RAVENSWORTH OPEN CUT

RAVENSWORTH OPERATIONS FINAL LANDFORM MODIFICATION – RESPONSE TO SUBMISSIONS

FIGURE 1

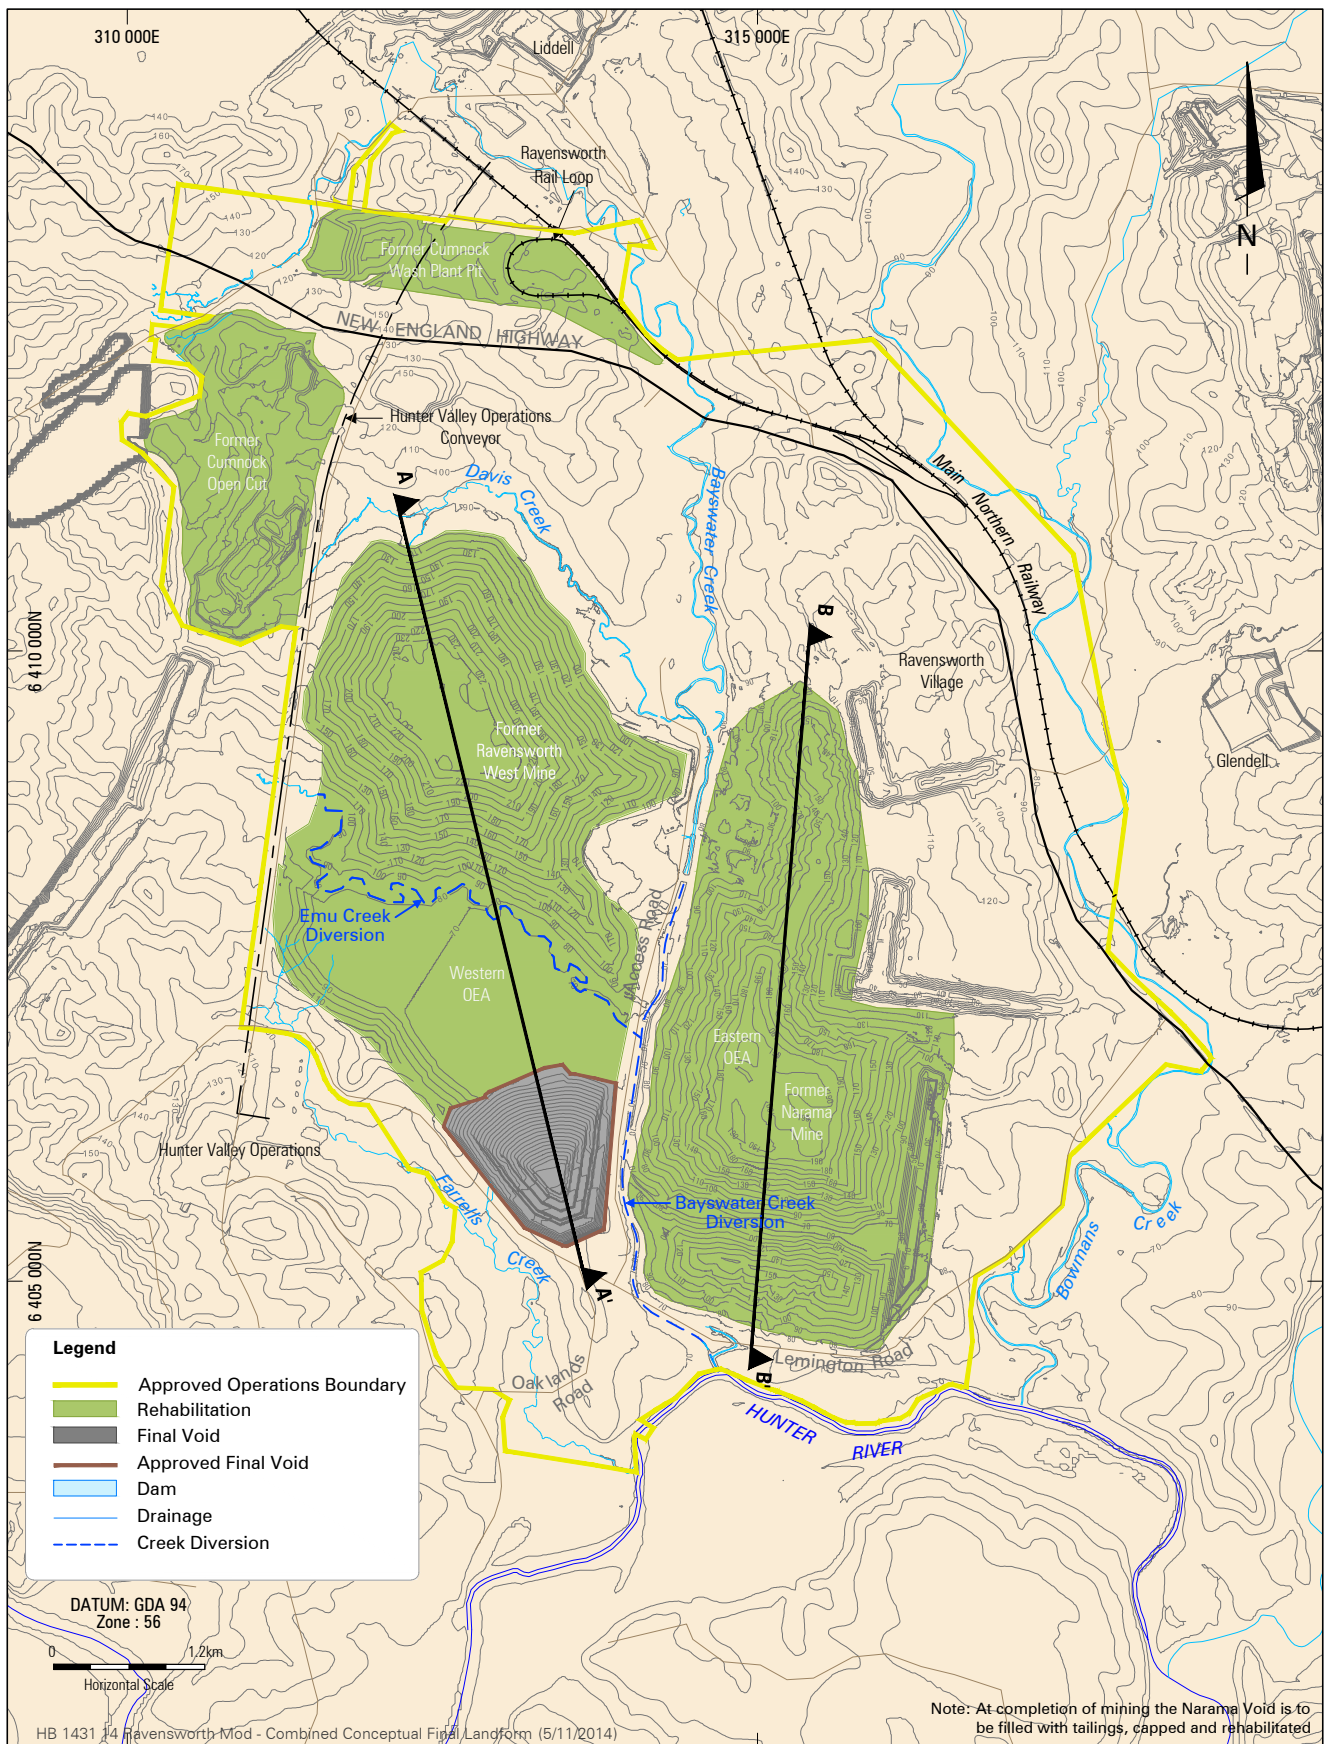
- Justification that a topographically diverse landform is not practical within current emplacement height restrictions;
- For each pit, justify the final void design and future use. There should be no increase in the number or size of final voids;
- Justify the need for water management (e.g. contour drains and sediment detention basins); and
- Detail the environmental net benefit of the proposed final landform design.

As depicted conceptually the Modification EA (Figure 3) has identified a small increase to the surface area of the final void. Following a meeting between representatives from DRE, Ravensworth Operations and Hansen Bailey on 6 November 2014 and to address the issues DRE identified in their correspondence dated 14 November, Ravensworth Operations has since completed additional mine planning in order to develop a landform with a void consistent to that approved.

As a result of this additional mine planning, an alternative Revised Conceptual Final Landform has been developed for the Modification (see **Figure 1**). In addition, a section line has been developed to provide a comparison between the alternative Revised Conceptual Final Landform with regard to the existing approved final landform (see **Figure 2**). This alternative Revised Conceptual Final Landform effectively ensures that the Western OEA north of the future Emu Creek Diversion remains as currently presented in the Modification EA however the landform south of the future Emu Creek Diversion will be constructed consistent with the landform currently approved (see **Figure 1**).

The alternative Revised Conceptual Final Landform ensures that the visual benefits of the Modification are maintained without altering the size, catchment area, maximum predicted water level or position of the approved final void. Given this outcome the final void is anticipated to remain as a groundwater sink as described in the Ravensworth EA.

As stated in Section 8.4 of the Modification EA, the Ravensworth MOP will be updated for the Modification to the satisfaction of DRE to include detailed water management design associated with the Revised Conceptual Final Landform presented in this correspondence (see **Figure 1**).

Given the reduced final void outcome presented on **Figure 1** (when compared to the Modification EA), combined with the improved topographical relief, the Modification will result in a net benefit in terms of an improved post mining landform with no additional environmental costs being incurred.
